P.P.D (Regularization NO : 165  
L.O 2017) 2021

VIDE LETTER NO : Reg.L /3615/ 2021  
DATE : /04/ 2021

IN-PRINCIPLE APPROVAL OF LAYOUT FRAMEWORK IN S.NO:706/5PT, 707/1, 708, 709PT & 710PT OF KORATTUR VILLAGE, GREATER CHENNAI CORPORATION AS PER G.O.(Ms) No:78 H&UD UD4 (3) DEPT. DT:04.05.2017 AND G.O.(Ms) No:172 H&UD UD4 (3) DEPT. DT:13.10.2017 AND OFFICE ORDER NO.15/2018 DT: 12.12.2018.

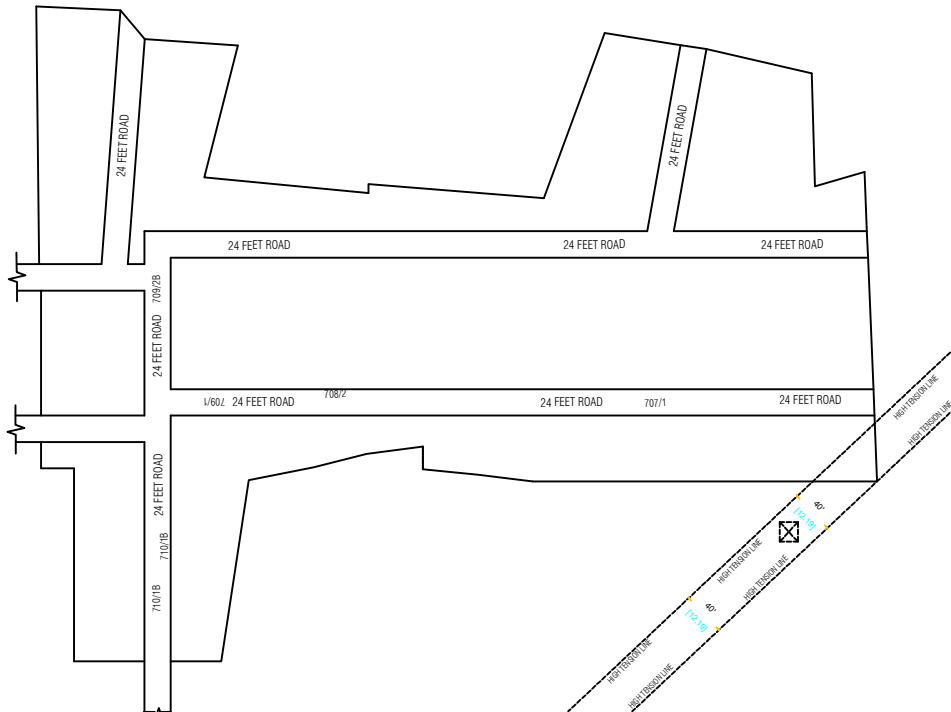
- 9) The S.No.707, 708 & 710 of Korattur village is close to water body, Hence GCC has to ensure that the site under reference is not part of water body and also to obtain NOC from PWD on inundation point of view.

- 10) The Regularisation of layout site was inspected by GCC and forwarded to CMDA with recommendation to accord framework approval. However the inspection report of GCC is not clear, the existing layout is meant for residential use. Hence GCC has to inspect the existing layout and confirm whether the existing layout is satisfies the conditions of Government Order for the regularisation of unapproved plots and layout rules-2017. If satisfies the Government Order, then in-principle layout framework may be considered. Since Plots/Sub-Divisions/Layouts shall be regularized under these rules only for Residential usage. GCC should ensure the same before regularizing the individual plot in the layout framework.

- 11) The Regularisation of layout site was inspected by GCC and forwarded to CMDA with recommendation to accord framework approval. The Shape and dimension of the layout framework is based on the sketch furnished by the applicant which was forwarded by GCC to CMDA. Hence any variation in the dimension and extent has to sorted out with respect to the FMB of the site by GCC and the applicant. Further connectivity of layout to the public road and internal road pattern shall be ensured by GCC before issuing final approval.
